DESIGN MEMORANDUM NO. 15

COOPER RIVER REDIVERSION PROJECT
LAKE MOULTRIE & SANTEE RIVER
SOUTH CAROLINA

WATER
MONITORING PLAN

SADEN-GP (23 Dec 77) 1st Ind
SUBJECT: Cooper River Rediversion Project, Design Memorandum 15. Water
Quality Monitoring Plan

FIGURE 2

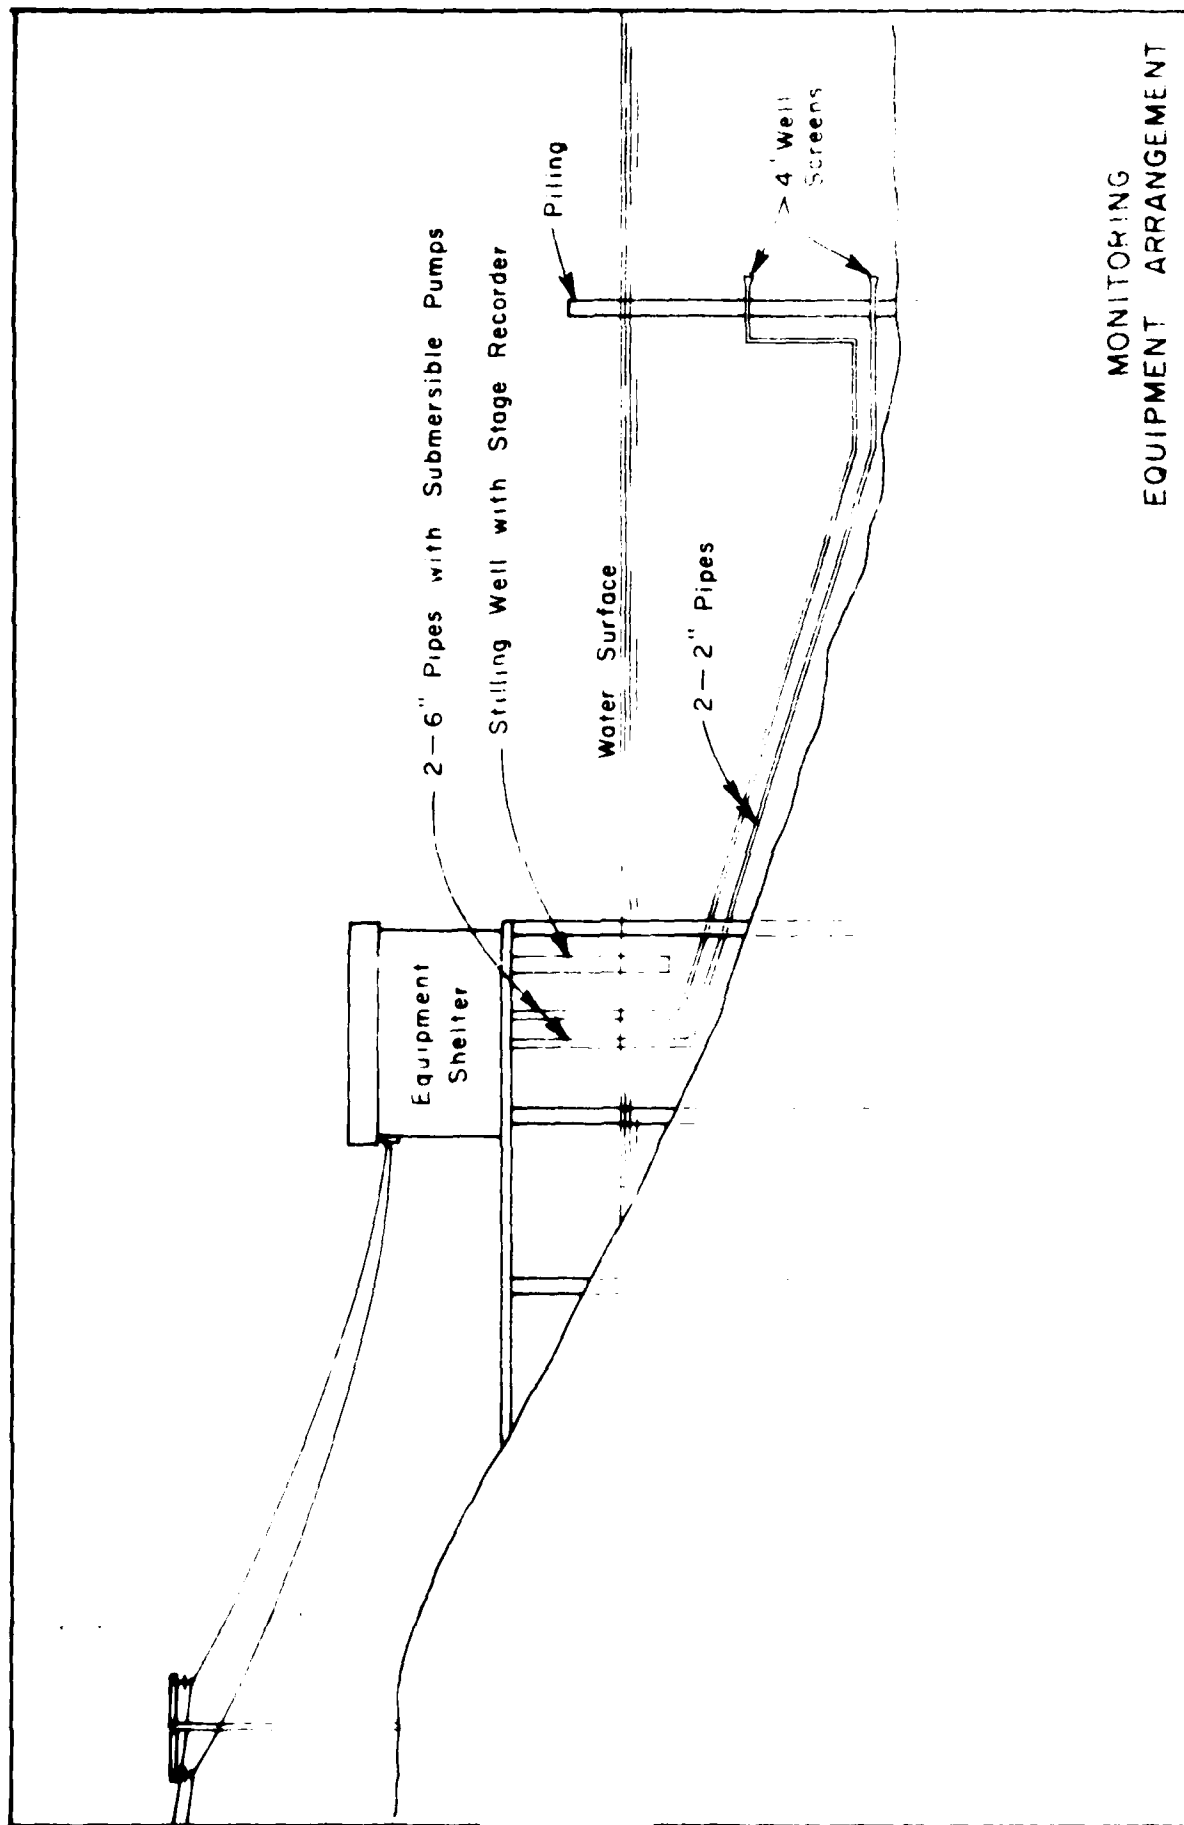
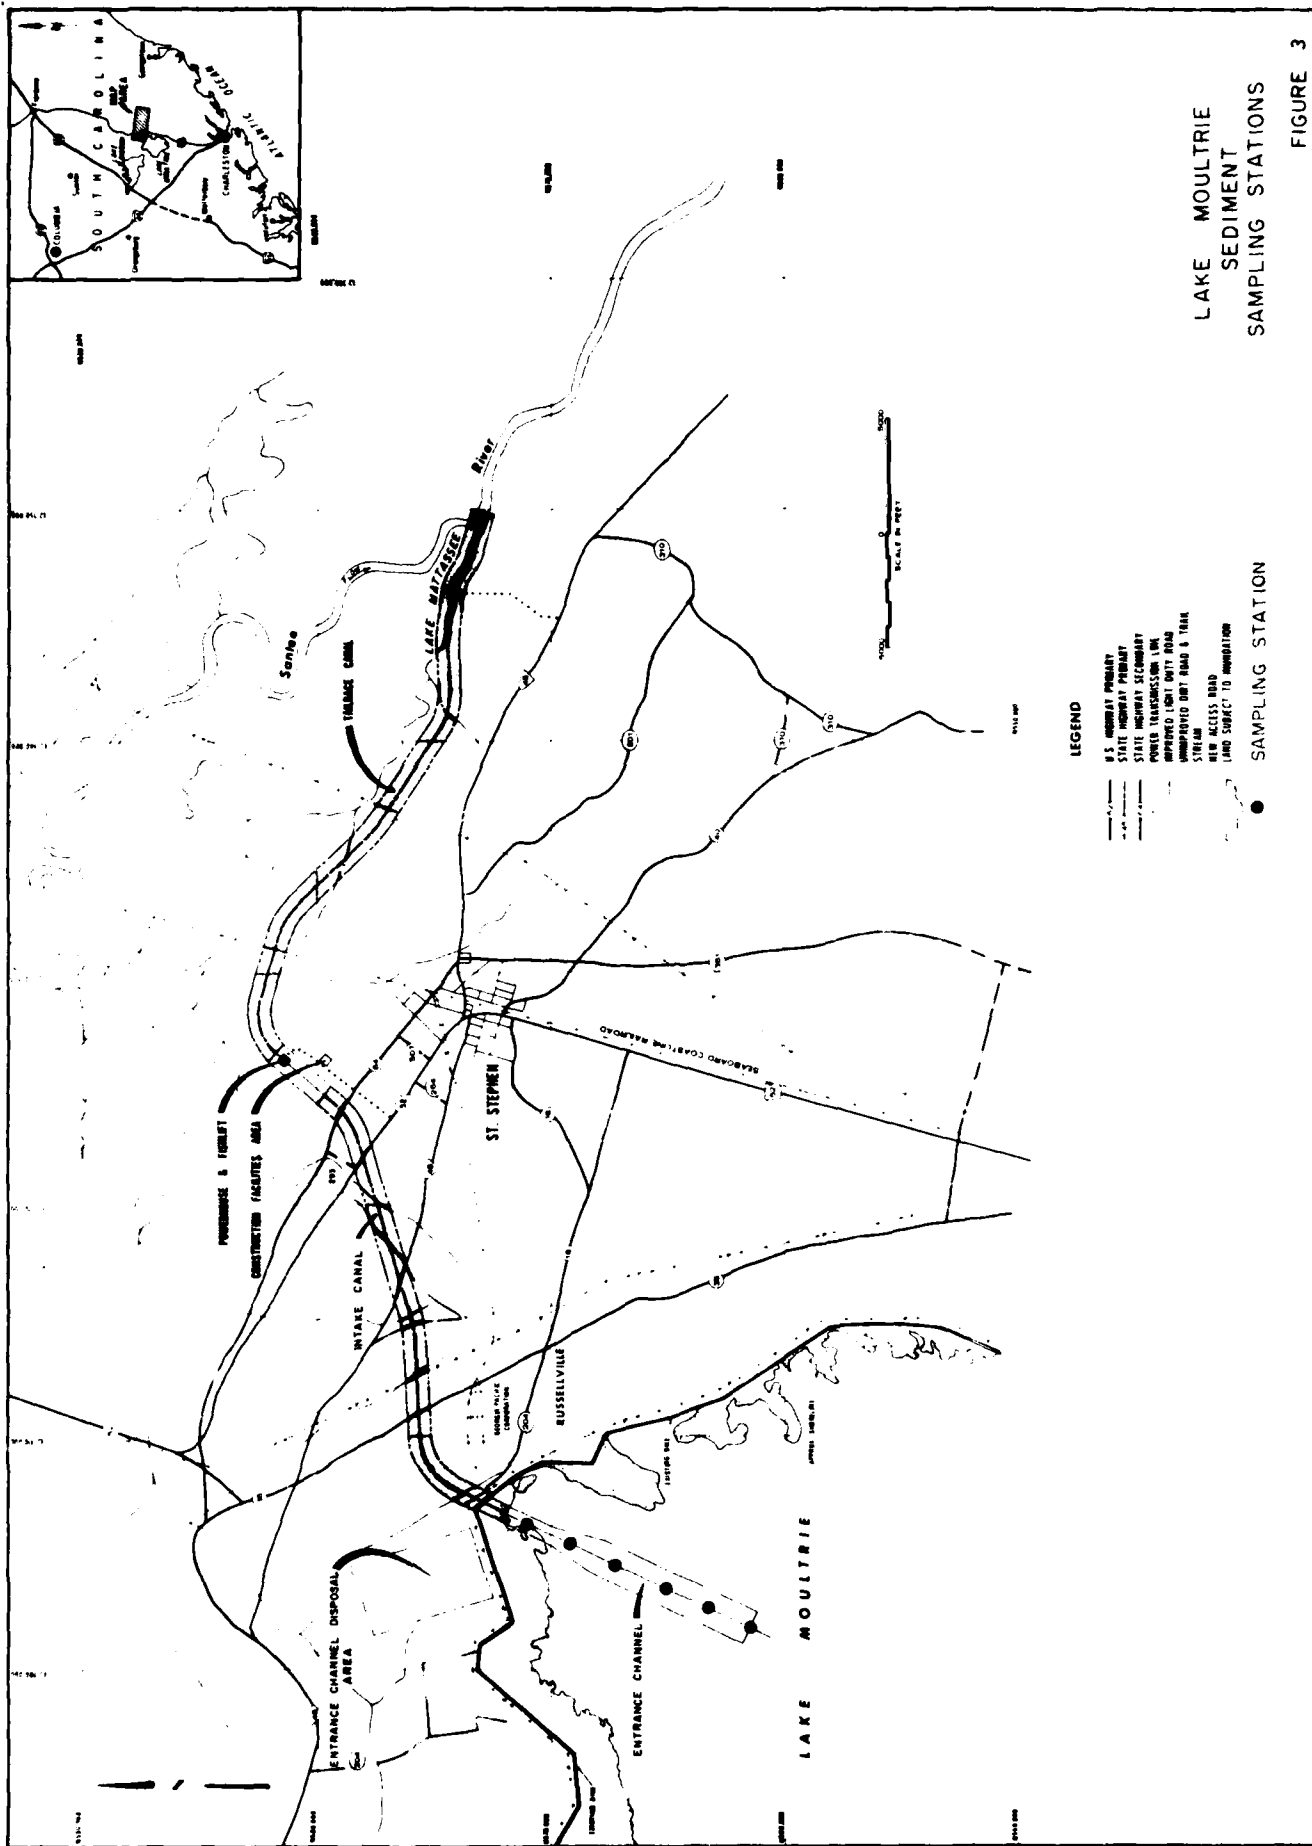
h. In order to insure earlier detection of possible salinity, the intake for Durham Canal monitor should be located at mid-depth in lieu of upper level.

9. Paragraph h. Since the salt wedge tends to move along the bottom, the intake for the Durham Canal monitor will have a bottom intake.

SCALE AS SHOWN	DM 15 WATER	PLATE 1
DATE MAR 78	MONITORING PLAN	FILE NO 10092

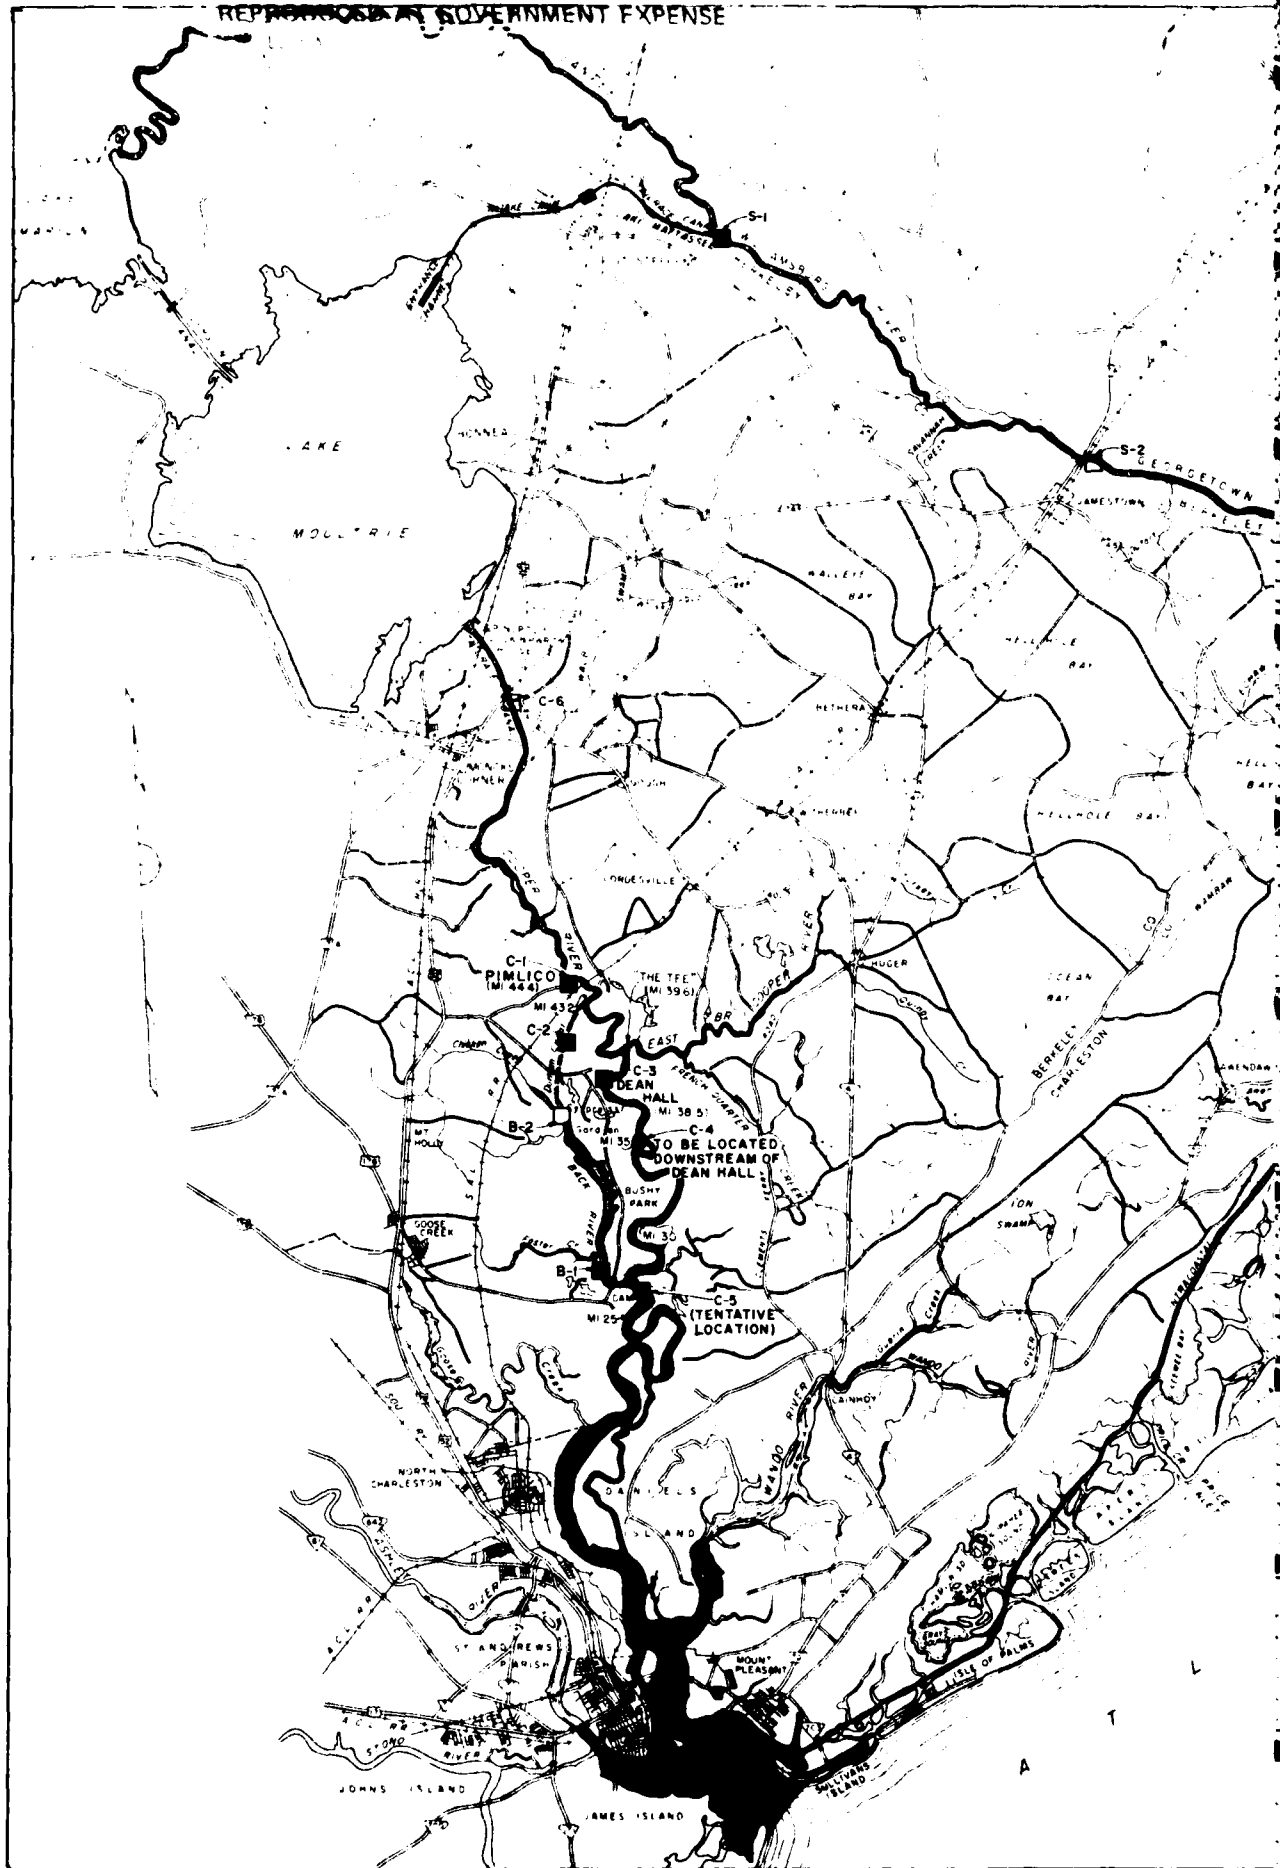
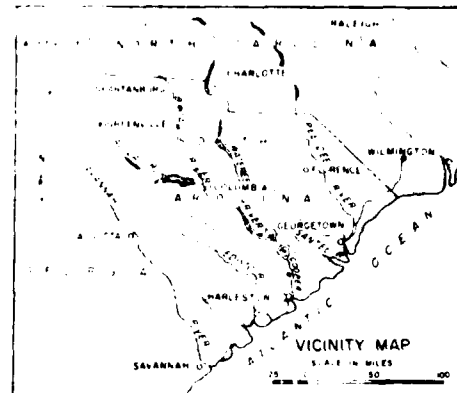
a. Page 4, paragraph 8. Water use classification. Suggest using a single line drawing in addition to this paragraph to show classification and relation to tributaries similar to attached drawing.

b. Page 11, paragraph 11. Environmental Protection Agency, (EPA) 1974. The maximum penetration (between mile 33.2 and 33.5) should be shown on a map of the area, i.e., plate 1. River mile 42, discussed in succeeding paragraph 13 should also be shown.

j. River mile locations should be shown on the plates and figures since they are frequently referenced in the DM.

2. Paragraph a. Included in Plate 1.
3. Paragraph b. River mileage has been added to Plate 1. Mileage figures shown in the report and on Plate 1 correspond to the same location given in the EPA report although the mileages are different.

11. Paragraph j. River miles have been included in Plate 1.
